Toomerfs' Misleading Claims & Unrealistic "Renderings"

Steeply Sloped Church Hill Woods
to Parking Mound Mesa, cont'd

May 6, 2022 Submission to the Durham Planning Board

Joshua Meyrowitz, 7 Chesley Drive, Durham, NH 03824 (n)

Project Name Continues to Mislead Planning Board & Public

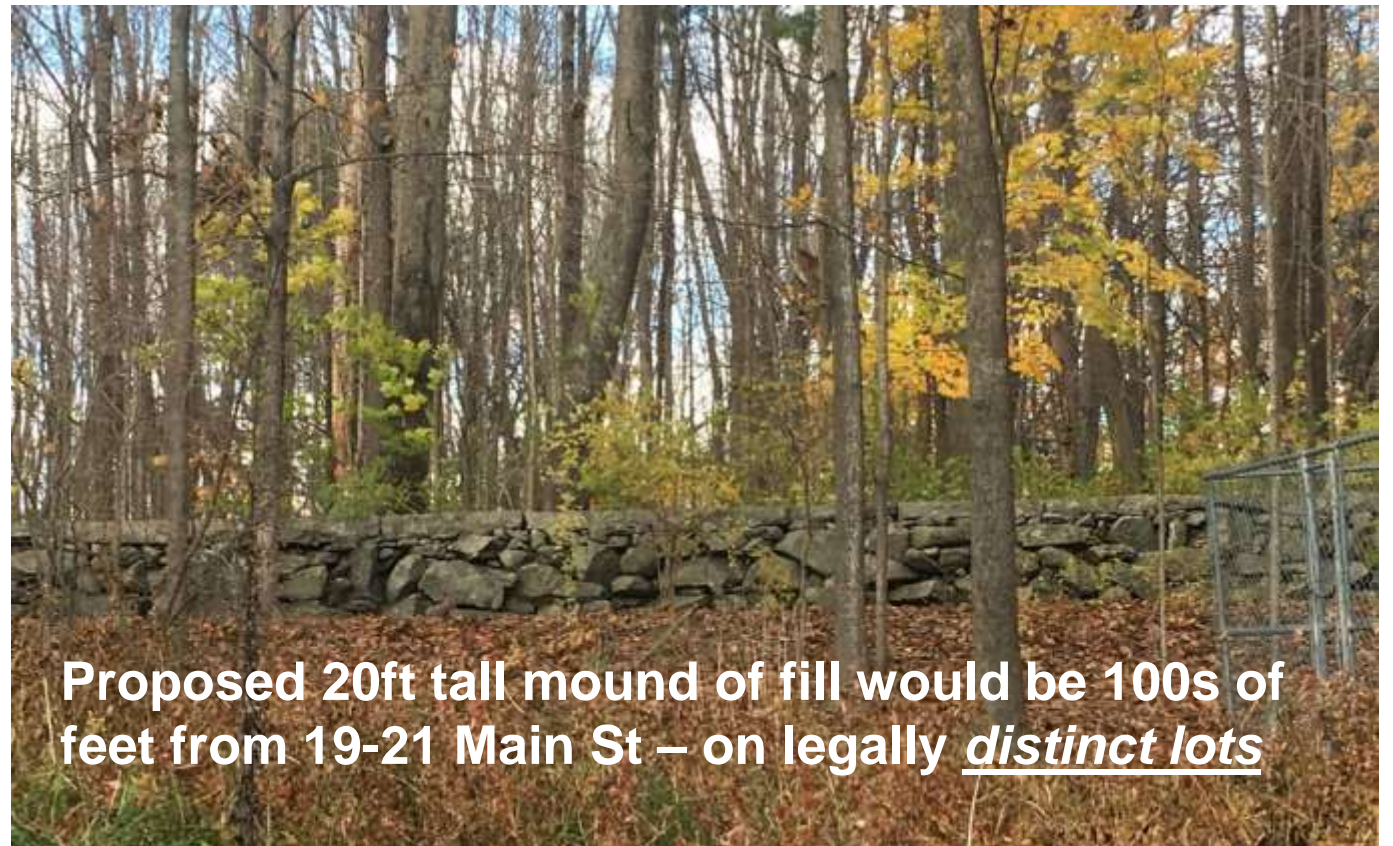
The proposed project is **NOT** located at “19-21 Main Street”

What applicants call REAR of plan (at Chesley Marsh) is FRONT for those most affected by it

“19-21 Main” = driveway entrance/exit to Historic District lots. Parking *expansion* proposed is **on two *legally distinct* landlocked lots (not in Historic District) with no street addresses, distant from Main St.**

May 12, 2021 – Post-ZBA plan: no retaining wall, much less fill, lower mound.

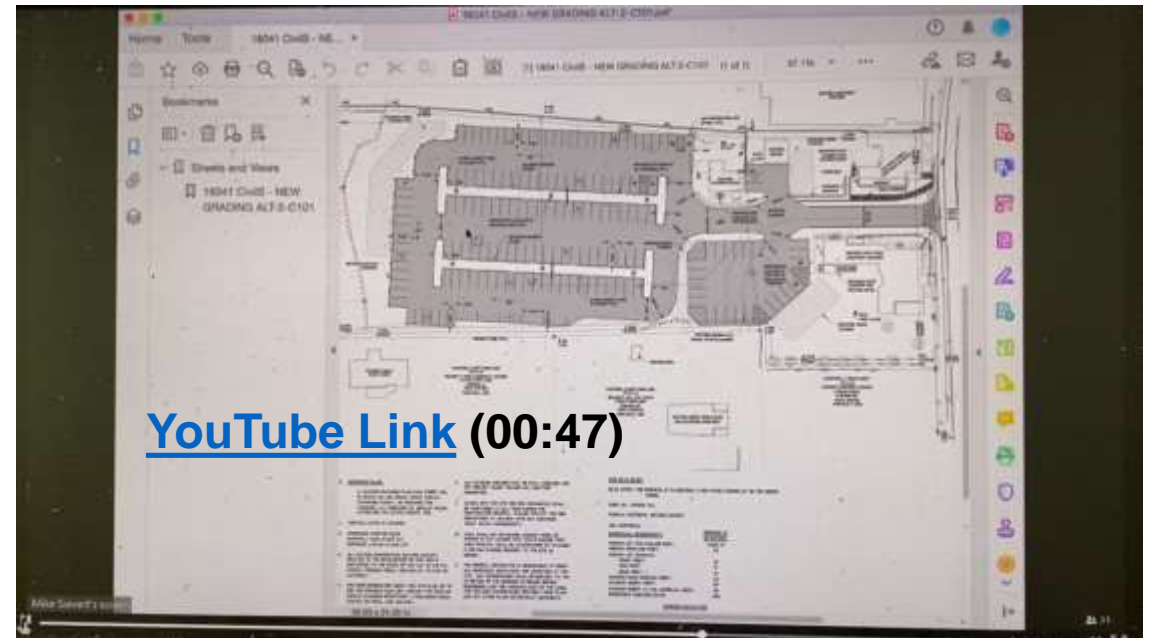
The “FORGOTTEN” Plan Two – but check the video link!

This was the “pitch” that sold PB on a new plan being ZBA-compliant, at-grade surface parking”

confirm: 6,000 CY **less** fill (vs. prior 17,000 CY = 11,000 CY); 5-6 ft **lower elevation** (vs. 17-ft prior = 11-12 ft elevation), and **no retaining wall at all** (vs. 20ft tall concrete wall topped with 30” black aluminum fence).

Bringing back “forgotten” Post-ZBA May 2021 Plan to insert some TRUTHS

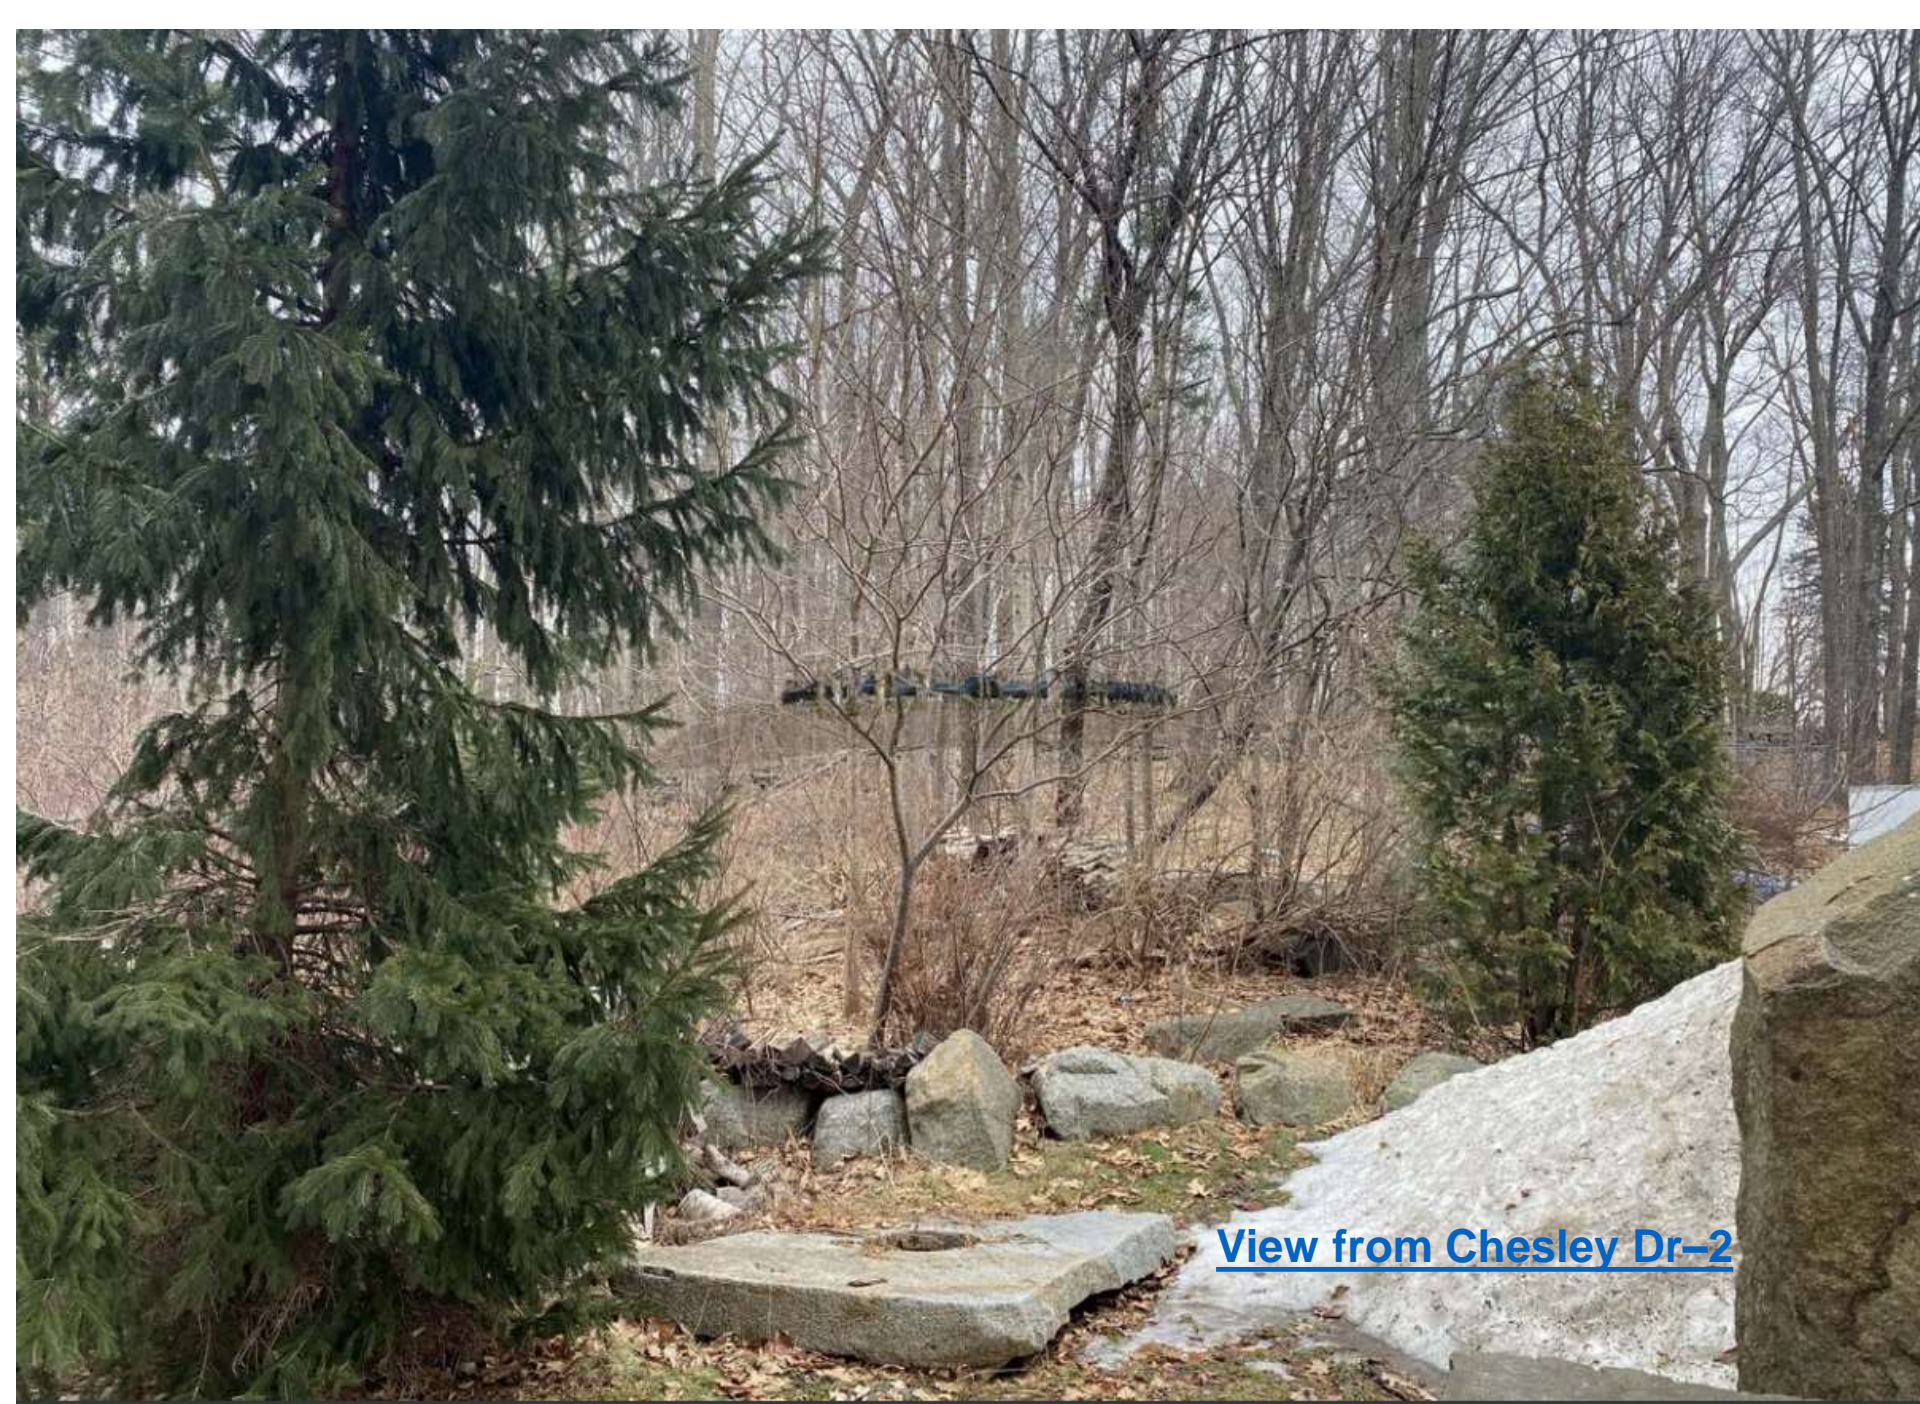
11-12 ft grade elevation

19-20 ft grade elevation

70% INCREASE

“NO RETAINING WALL WHATSOEVER”

RETAINING WALL STEALTHILY RETURNED

25% INCREASE

22% INCREASE

Six-foot tall Anton Andersen at Sievert's 100-ft~ setback marker from May 26, 2021 Site Walk (setback buffer has now been halved)

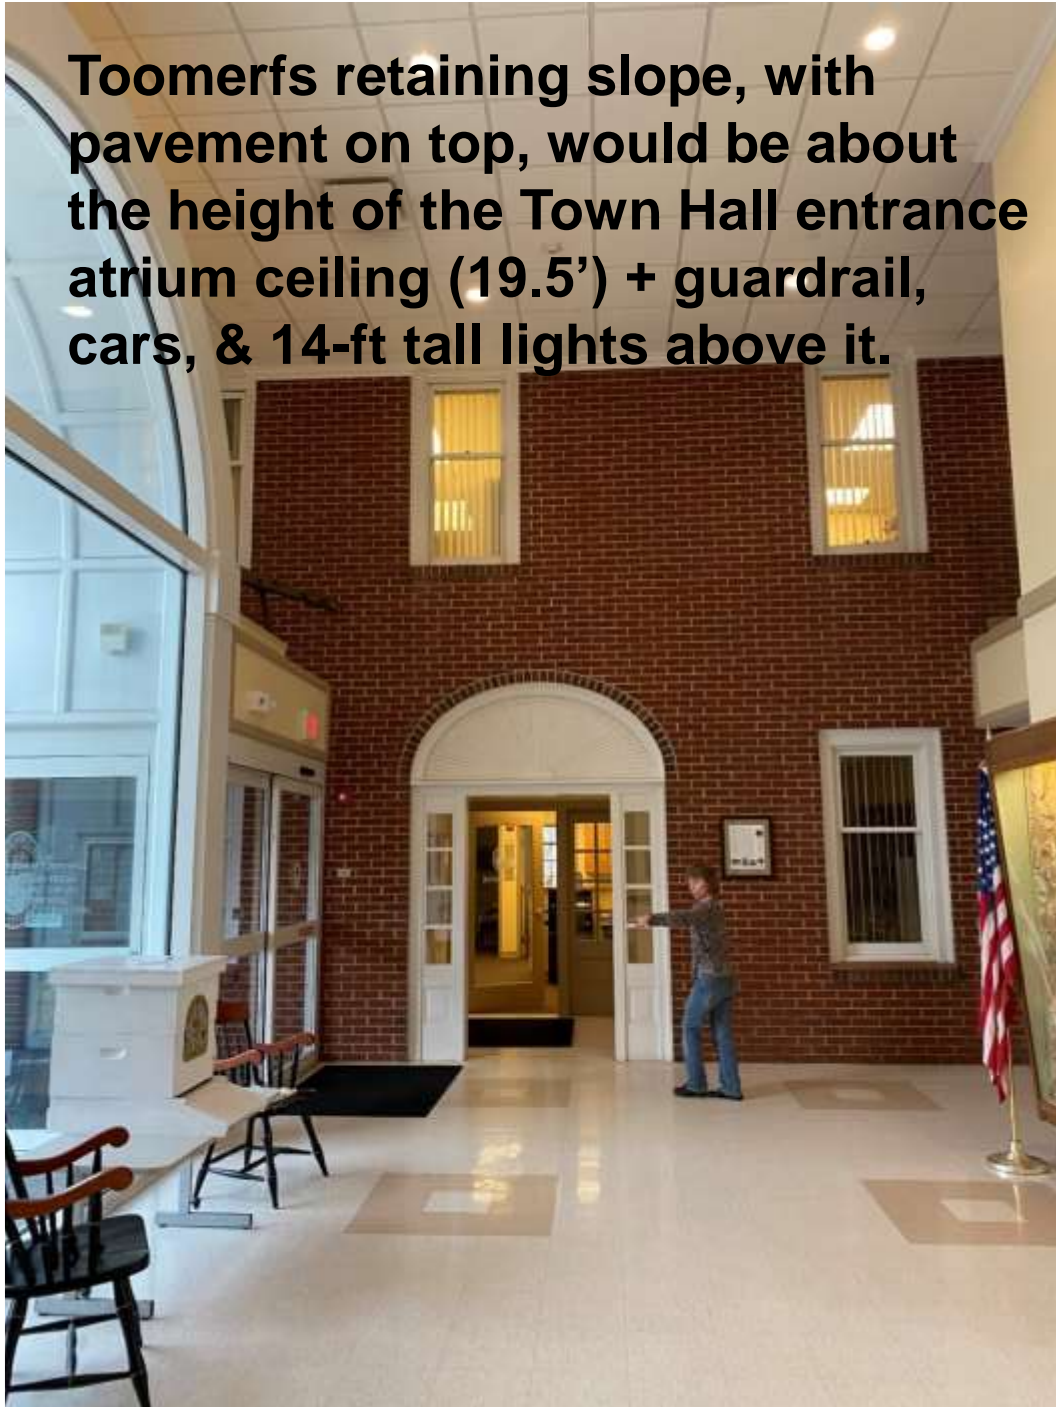
**How visible
would a 6ft tall
retaining wall
be behind the
old rock wall?**

**Judging by the
6-ft tall Anton
Andersen,
VERY visible.**

**But not
according to
Toomerfs'
"renderings."**

[View from Chesley Dr-1](#)

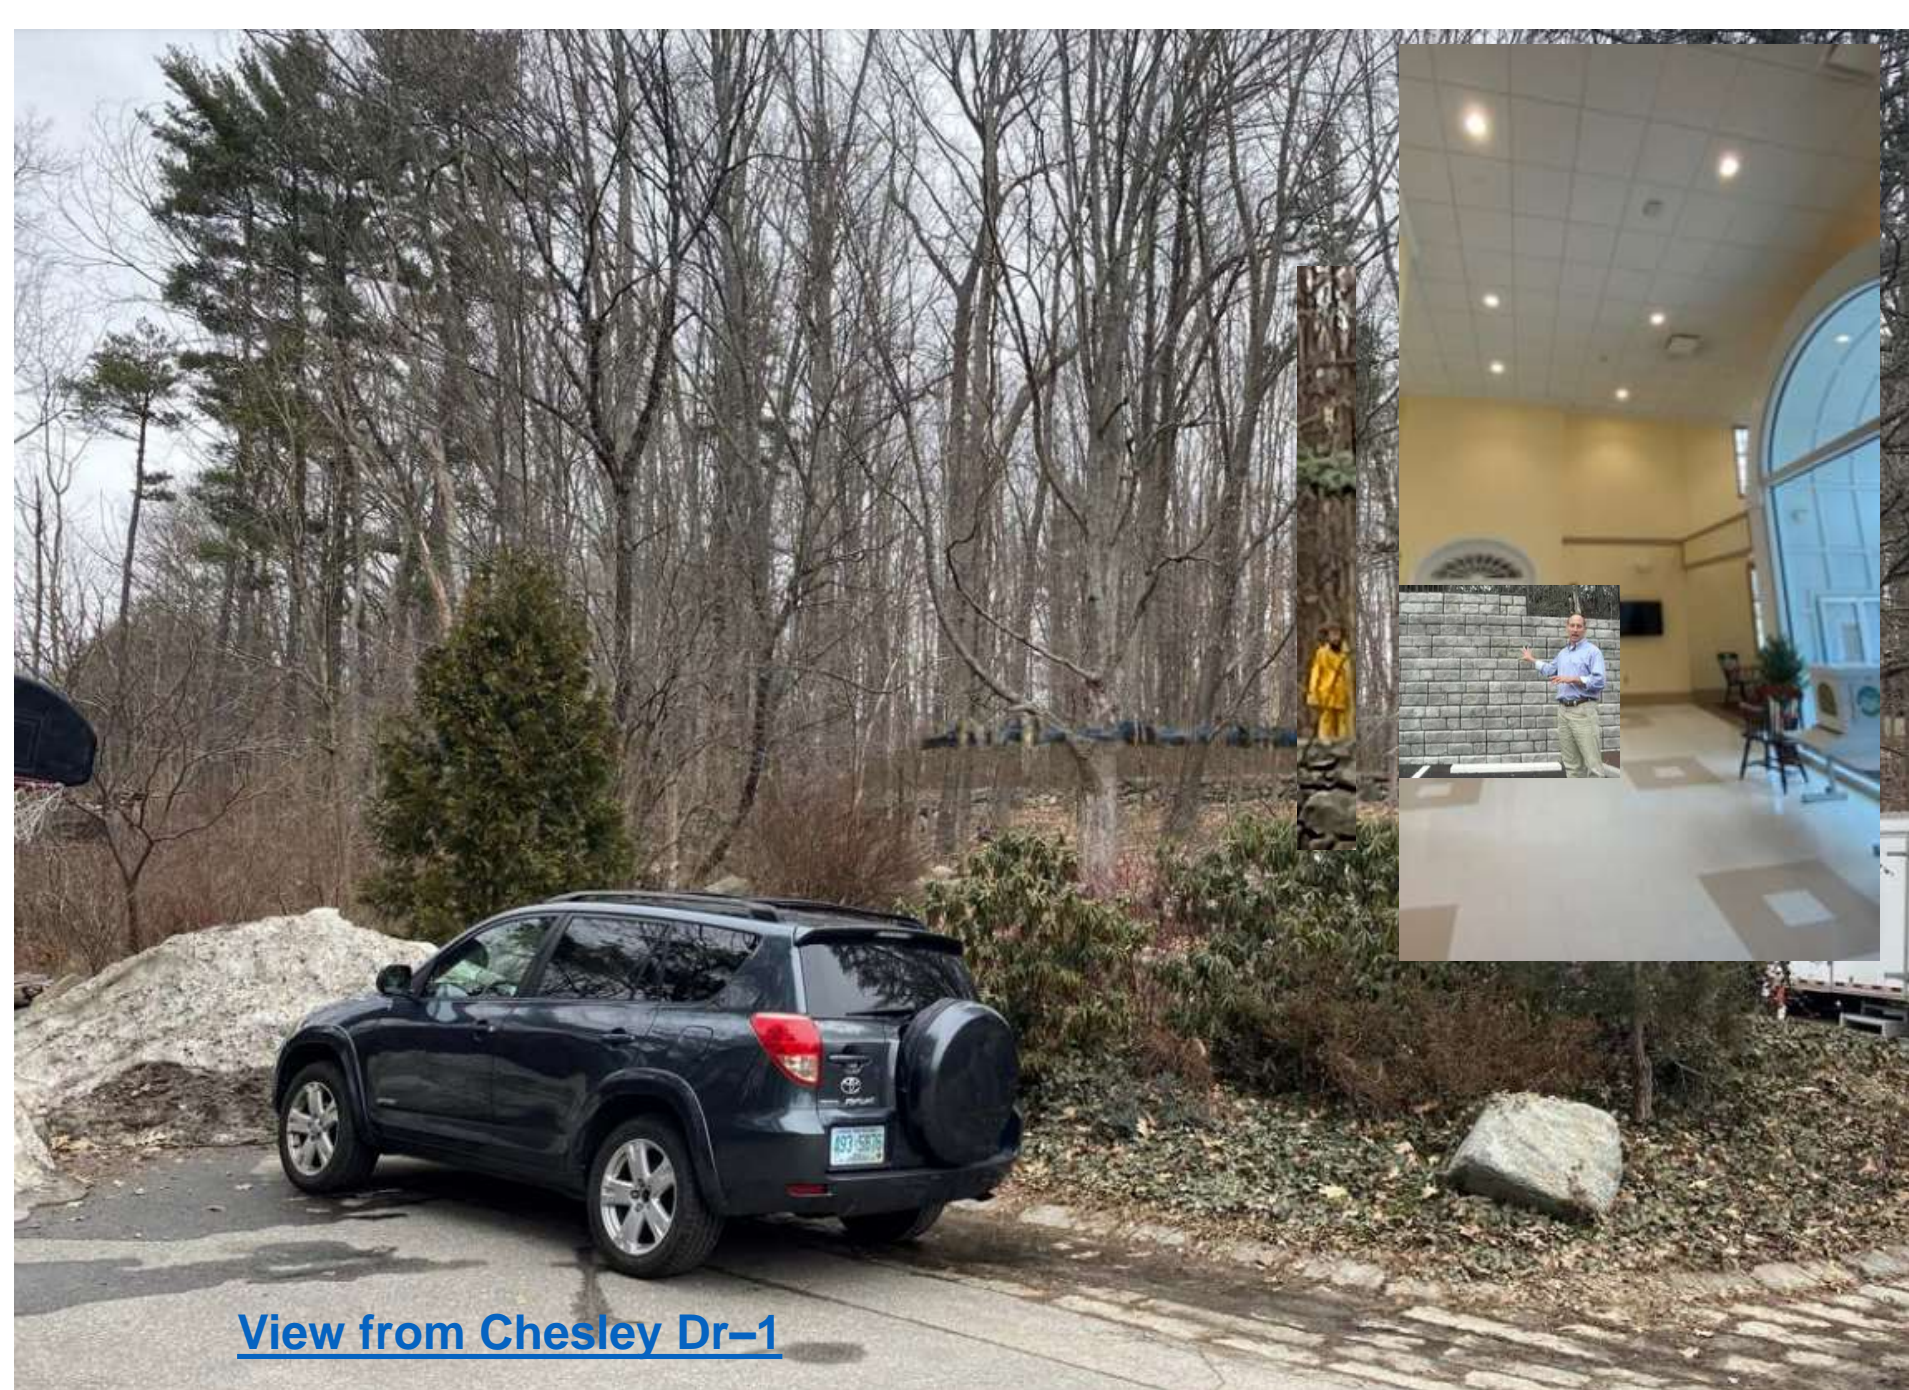
At about 20 feet high, the proposed steep slope* would reach up about 14 feet above the proposed 6-ft retaining wall (for an edifice about the height of the Town Hall Atrium entrance).

*The proposal is for a 2:1, or 50%, slope, that is: 1 foot of rise/drop for every 2 feet of run

Surely, the proposed 2-story tall retaining wall/retaining slope edifice, topped with a guardrail, vehicles, and lighting poles – *and a big void where the trees now are* – would be more visible from Chesley Dr than Toomerfs' images suggest.
